State of New Mexico
Energy, Minerals and Natural Resources

SUNDRY NOTICES AND REPORTS ON WELLS
(DO NOT USE THIS FORM FOR PROPOSALS TO DRILL OR TO DEEPEN OR PLUG BACK TO A DIFFERENT RESERVOIR. USE "APPLICATION FOR PERMIT" (FORM C-101) FOR SUCH PROPOSALS.)
1. Type of Well: Oil Well [ ] Gas Well [ ] Other [ ]
2. Name of Operator
3. Address of Operator
4. Well Location
Unit Letter \_\_\_\_\_ : \_\_\_\_\_ feet from the \_\_\_\_\_ line and \_\_\_\_\_ feet from the \_\_\_\_\_ line
Section \_\_\_\_\_ Township \_\_\_\_\_ Range \_\_\_\_\_ NMPM \_\_\_\_\_ County \_\_\_\_\_
11. Elevation (Show whether DR, RKB, RT, GR, etc.)

Production, NORTHEAST DRINKARD UNIT 604 - Original Hole,  
Vertical schematic (proposed)

Administrative Order WFX-1044  
February 9, 2022

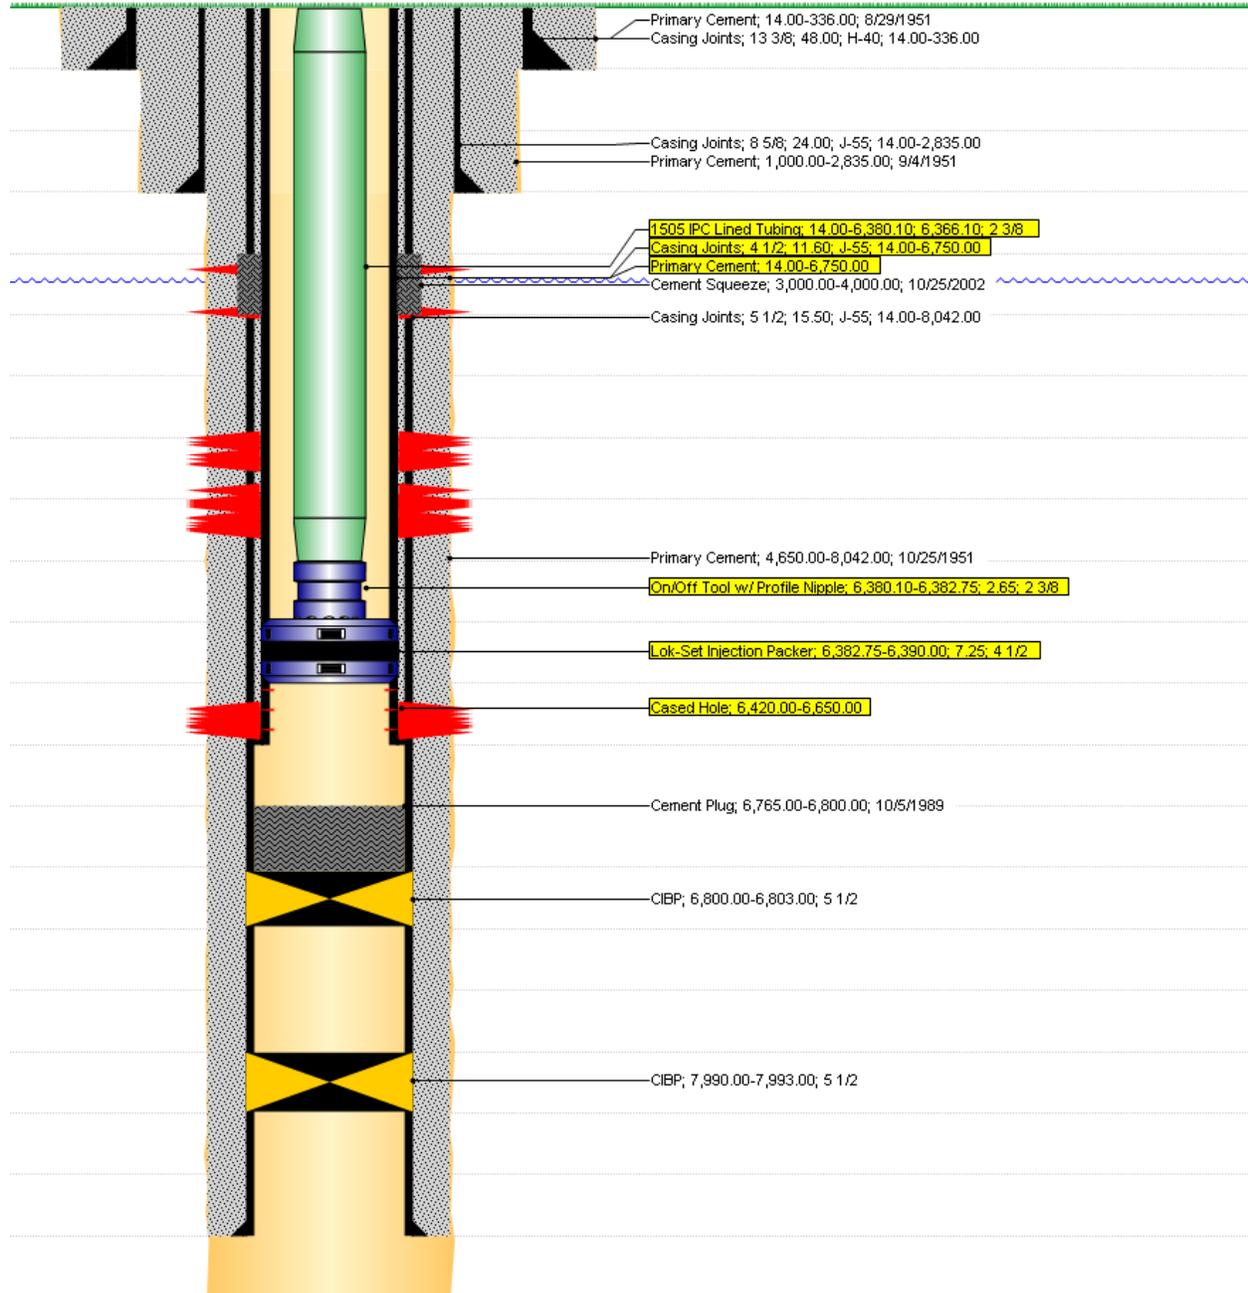
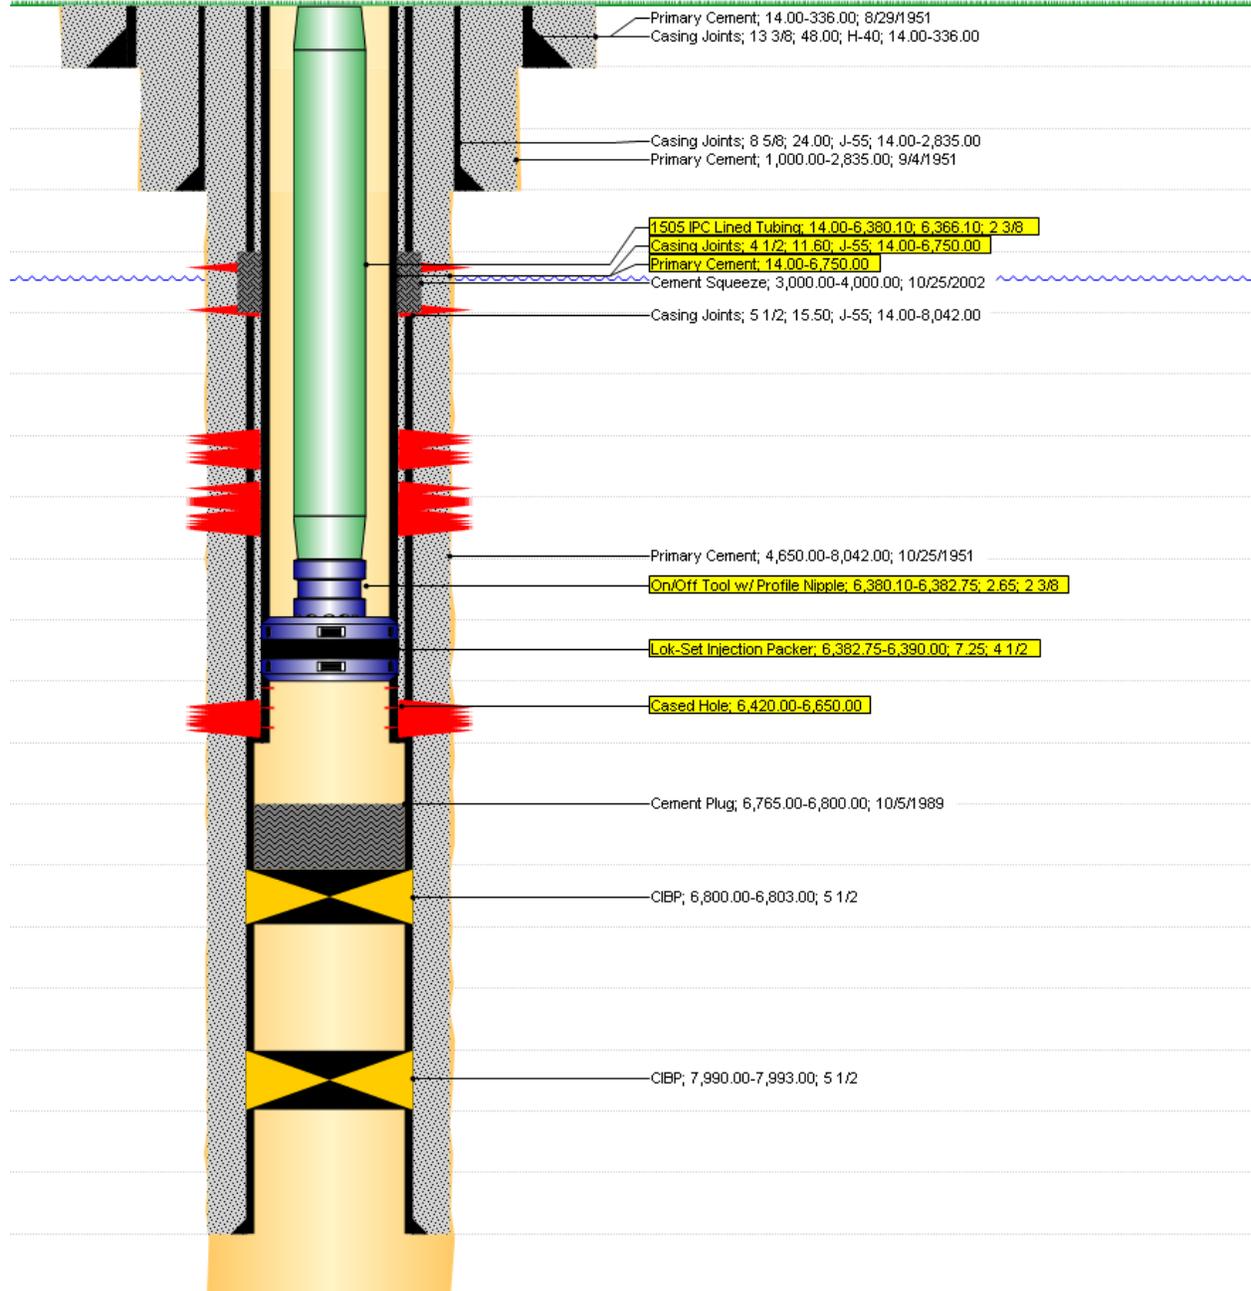
Condition of Approval: notify
OCD Hobbs office 24 hours
prior of running MIT Test & Chart

Created By	Condition	Condition Date
kfortner	Run post workover MIT test	3/11/2022
